ZED-R16 FireWire bus ground connection check procedure.

Picture 1.

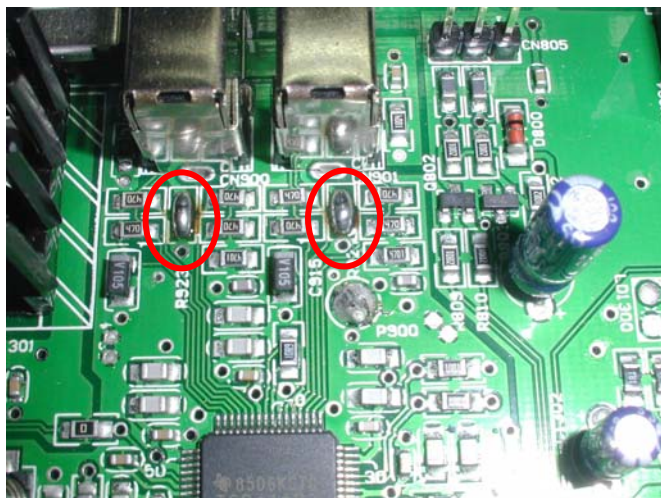
During the manufacturing process of ZED-R16, two 0R link resistors were omitted from a batch of FireWire circuit board assemblies. These links join the FireWire bus ground to the circuit ground and, if missing, there is a chance of intermittent connection between ZED-R16 and the FireWire host machine, resulting in audio dropouts.

- 1) Disconnect all cables from ZED-R16 & turn upside down.
- 2) Remove all the screws from the base panel (T10 head) and carefully remove the base.
- 3) Inspect the FireWire PCB AG7073 to see if R923 & R924 are fitted or not (Picture 1), if not then they can be either fitted or the pads can be solder blobbed together (Picture 2)
- 4) Also check that the two green wires are fitted to the FireWire board, one to P900 and one to P1310 (SGND), if these are not present please fit. (Picture 3, 4 and 5)
